Item Name: Quick Release Heli-Utility-Basket™ Long, HD Lid, Spacepod™/Squirrel Cheek Comp.

DART SERVICE INSTRUCTION

TO AMEND INSTALLATION INSTRUCTIONS D350-607-3 Rev.D,
INSTALLATION INSTRUCTIONS D350-607-4 Rev. C AND
INSTRUCTIONS FOR CONTINUED AIRWORTHINESS ICA-D350-607 REV. 6
REF TCCA STC: SH94-14
REF FAA STC: SR00213NY
REF EASA STC: EASA.10016996
REF BRAZILIAN STC: 2007S03-03/-04/-05/-06

FIGURE 1: INSTALLATION OF D4775-041 FWD STRUT

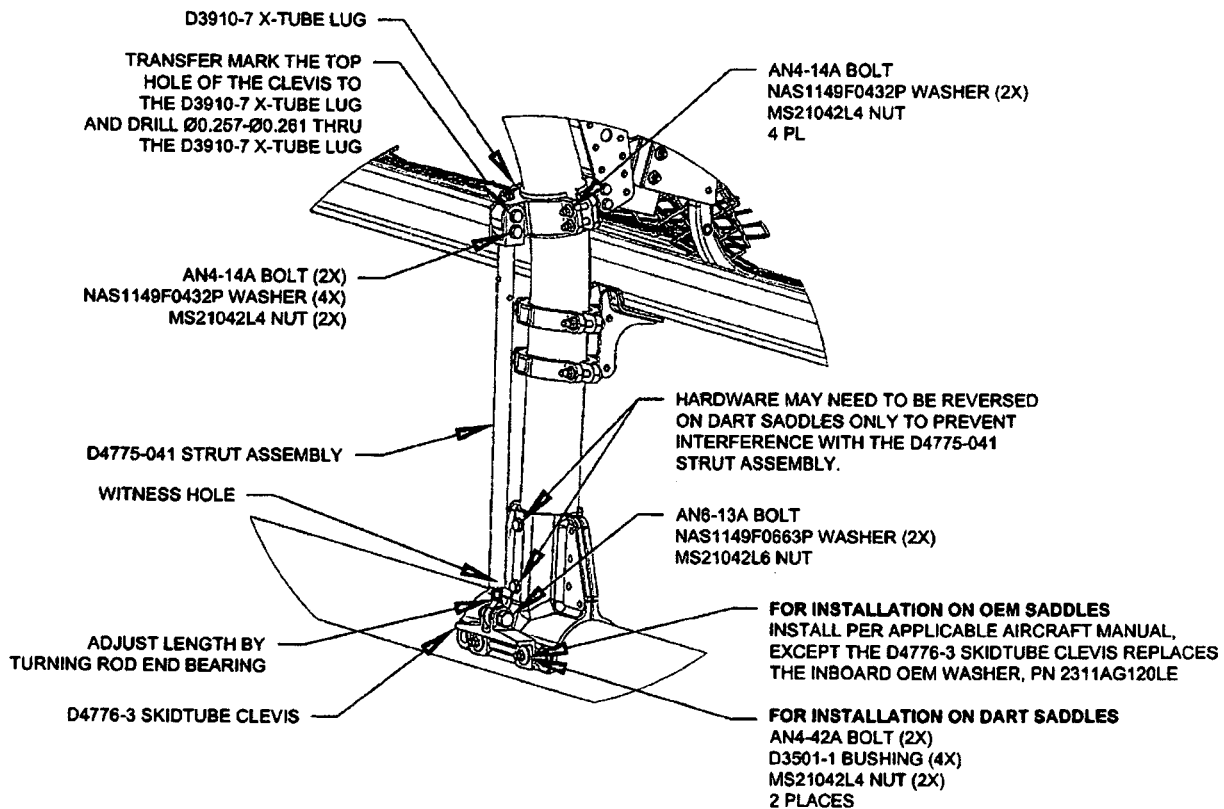
Modify the quantities for D3910-5 and add D3910-7 as follows:

- 3.1 Substitute the Forward Lower D3910-5 X-Tube Lug with the D3910-7 X-Tube Lug as shown in Figure 1.
- 3.2 Install the forward D4775-041 Strut Assembly. Transfer mark from the upper hole on the clevis of the D4775-041 Strut Assembly to the D3910-7 X-tube Lug and drill thru the lug $\varnothing 0.257$ - $\varnothing 0.261$ as shown in Figure 1. Touch up chemical conversion coating per MIL-DTL-5541. Check the witness holes located at the bottom end of the D4775-041 Strut Assemblies to ensure that the thread from the rod end extends past the witness hole.
Torque MS21042L4/-4 nuts to 50-70 in-lbs (5.7-7.9 N-m). Torque MS21042L6/-6 nuts to 160-190 in-lbs (18.1-21.5 N-m).
- 3.3 Complete the installation in accordance with Installation Instructions D350-607-3 Rev. D or D350-607-4 Rev. C.
